**SITE PLAN: LOT 327, PHASE 4,
THE PARKE AT OCEAN PINES, SECTION 16 OF OCEAN
THIRD TAX DISTRICT, WORCESTER COUNTY, MARYLAND**

Worcester County Critical Areas Review

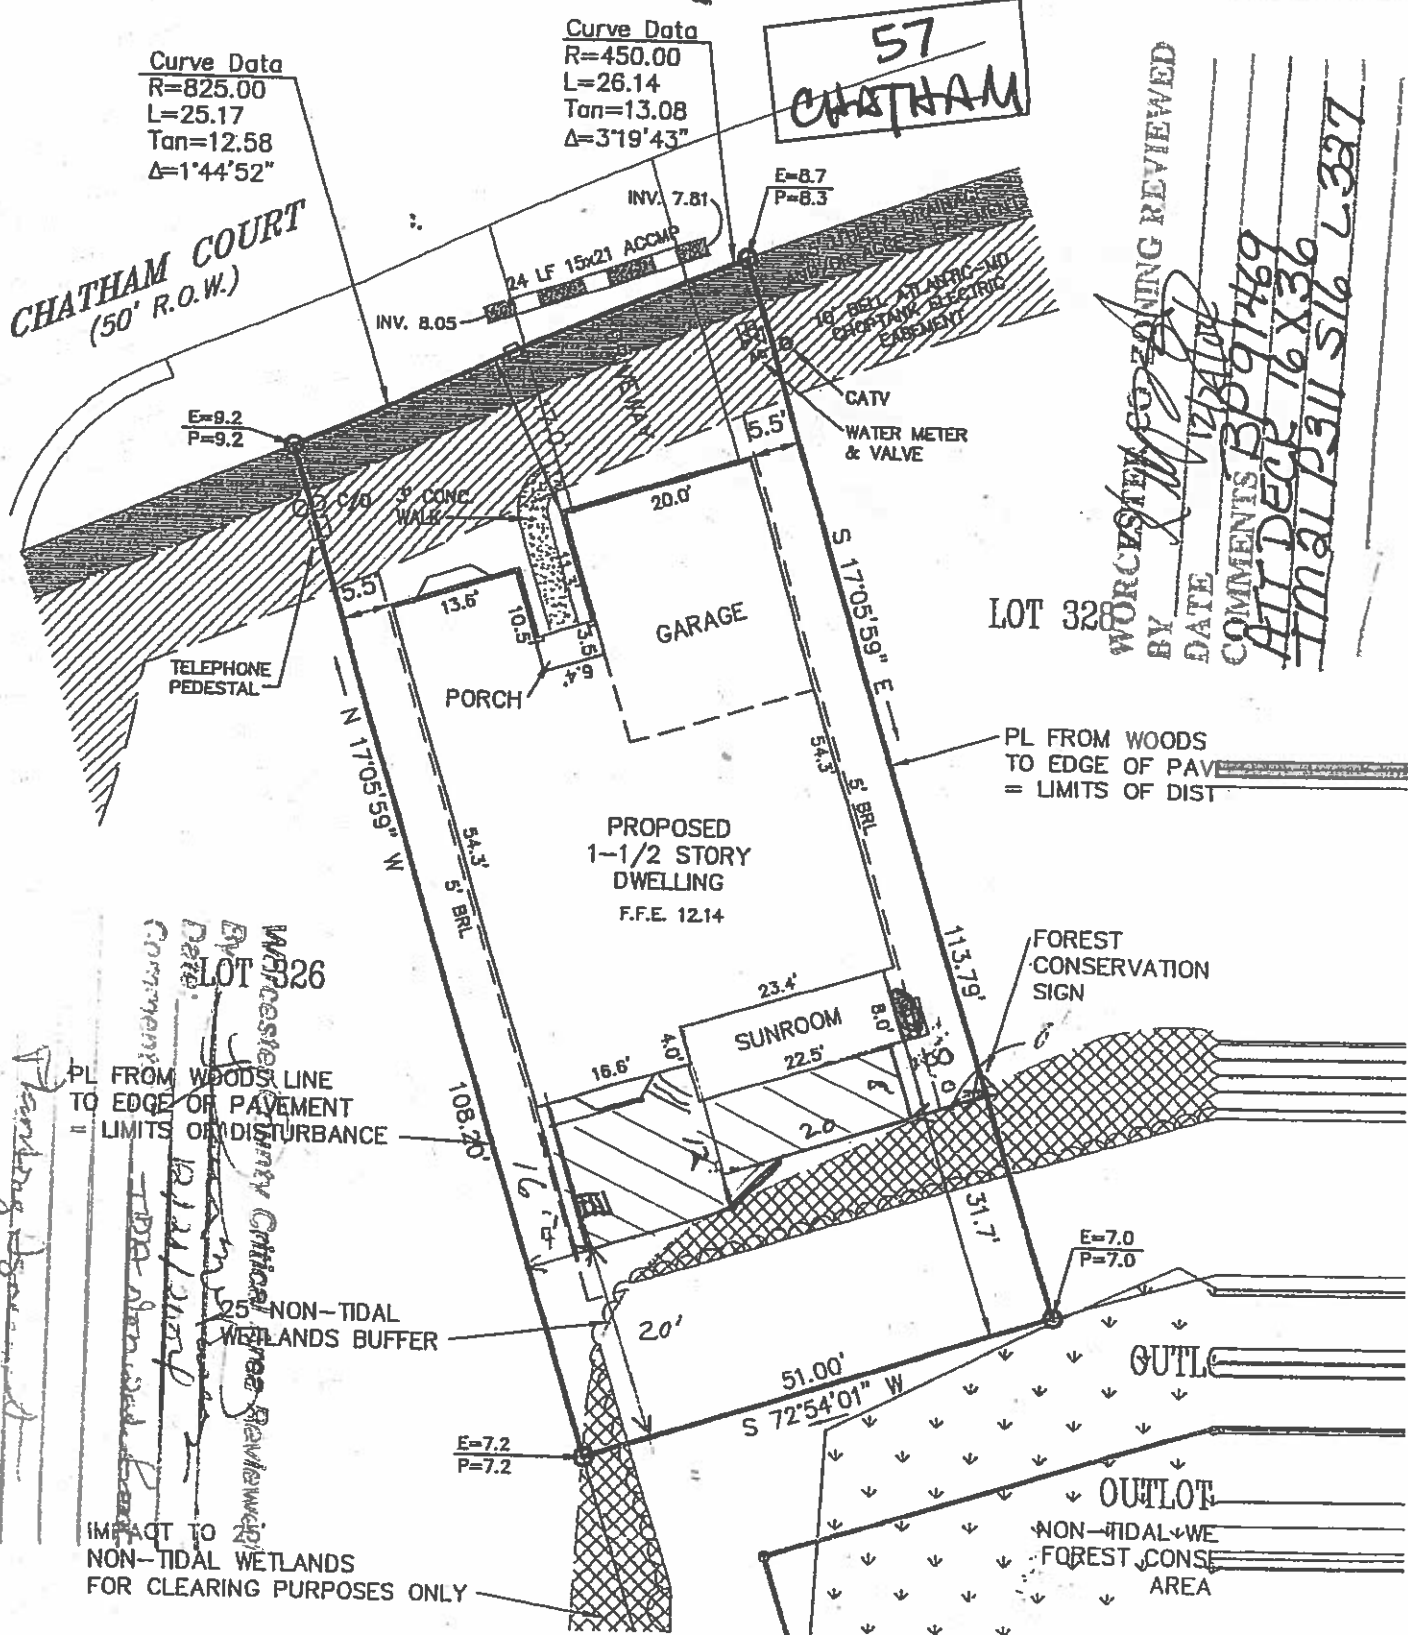
Comments: Retain wetland buffer
